**HarborView Block**  
 Portland, Maine

RE: HarborView Block  
Traffic and Parking Review

**RE: Harbor View Block Site Plan Review**

**RE:** 145 Commercial Street  
(city block bounded by Commercial, Fore, Market & Silver Streets)

FIVE ST. LEVEL PARTIAL PLAN

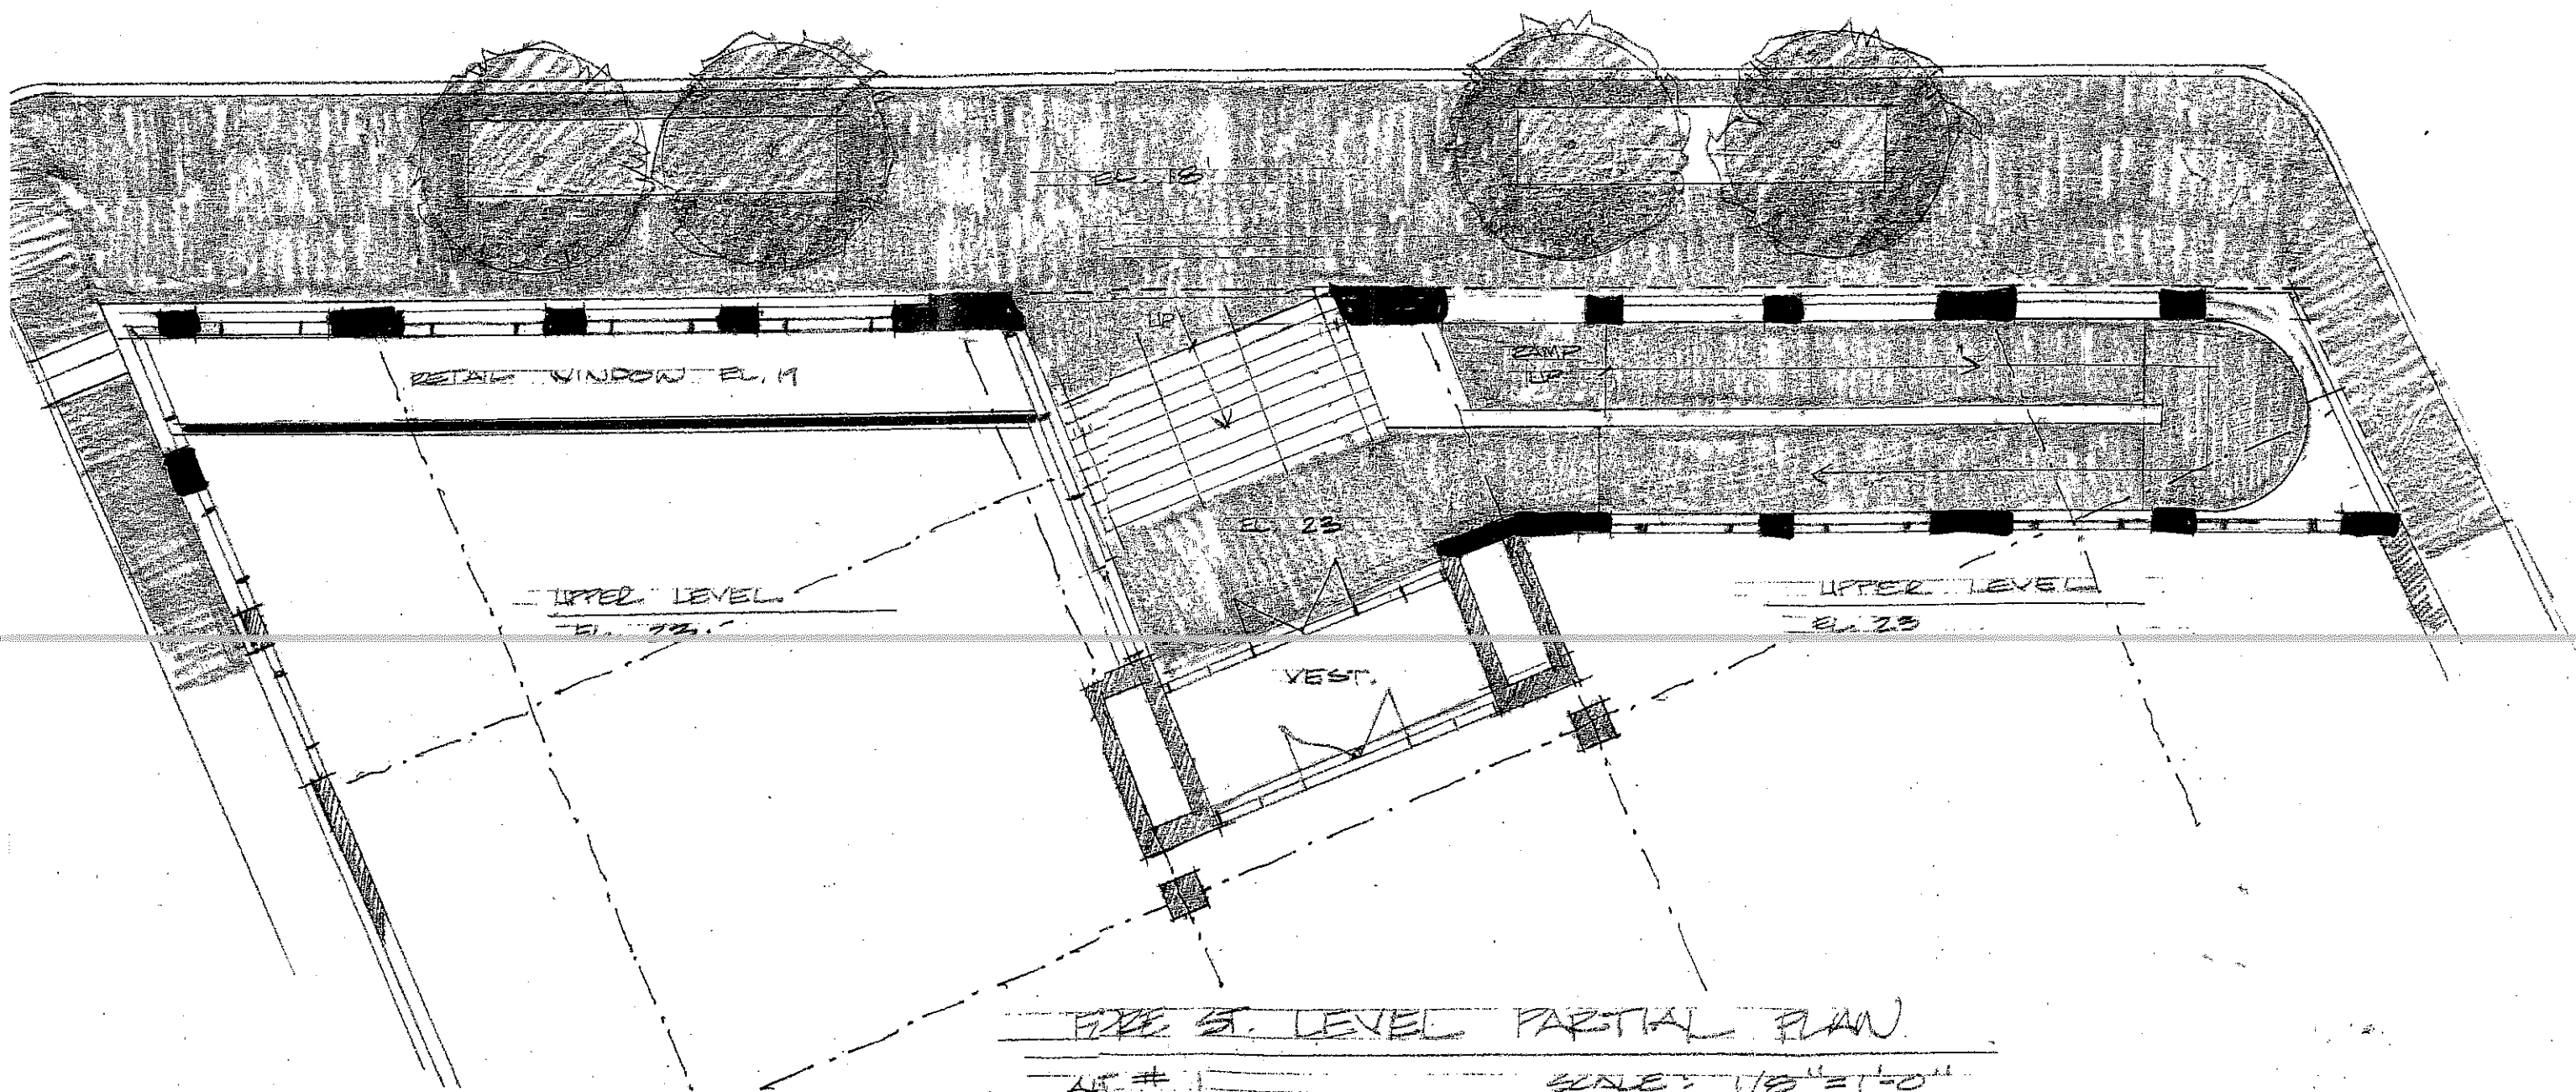
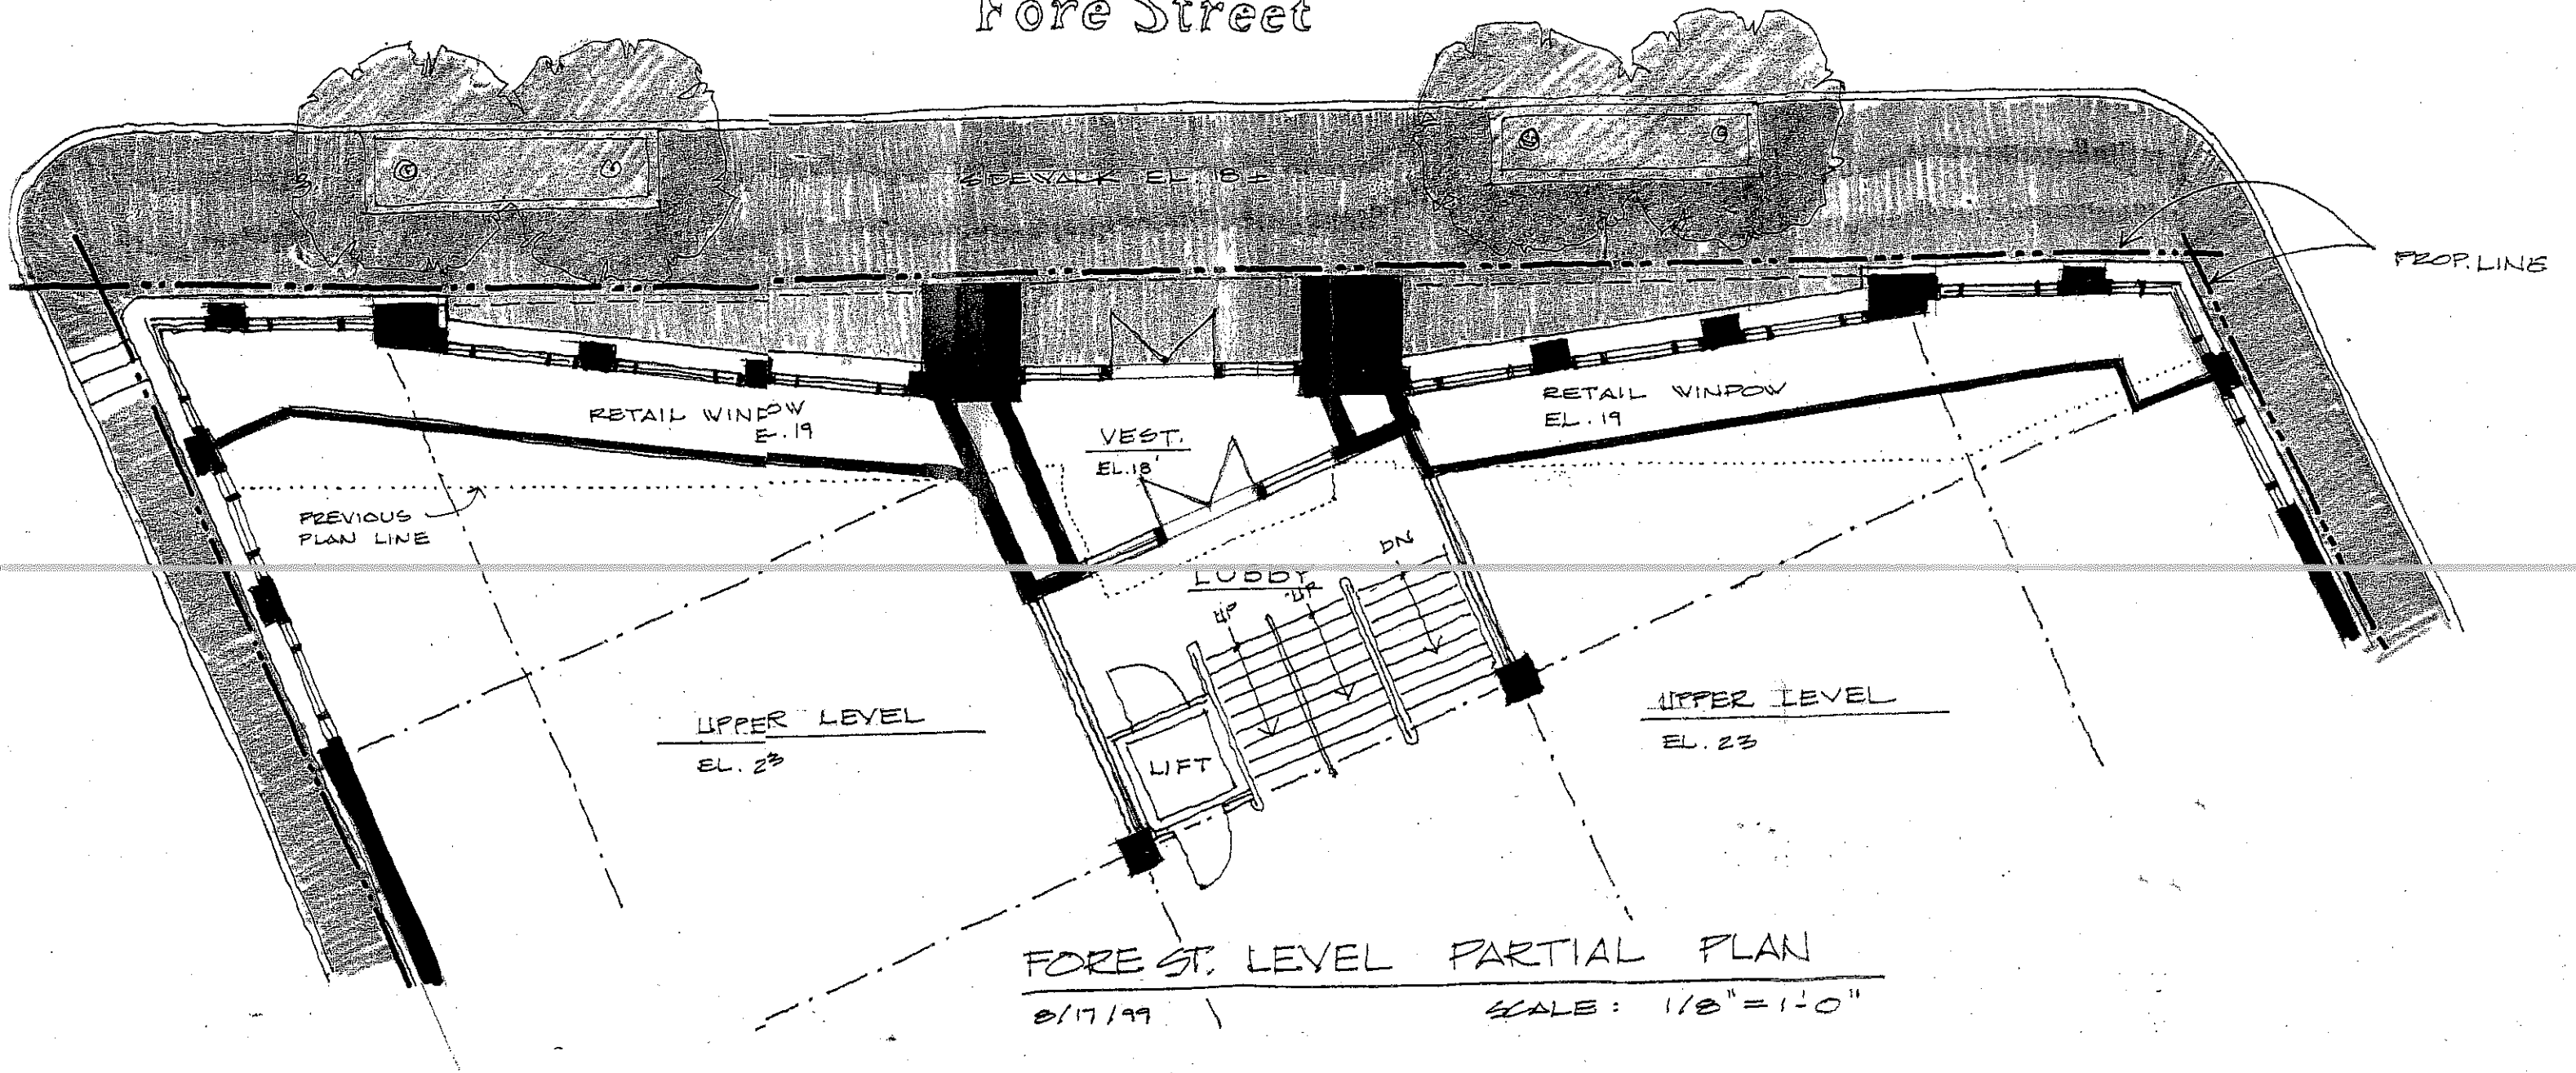
- The second plan calls for the façade to be moved to the street and then to be slightly concave in the center to allow for a center lobby with a mechanical handicapped lift. The street wall is addressed by putting window wells across the entire façade and setting the floor plate 3' back. The window wells in this plan present much of the same problems that the first does and that it is our opinion that it gives a false façade and makes the building appear as if the windows were after thought. The fact that the floor is moved forward to the street would have pedestrians looking in at the ankles and bottoms of desks
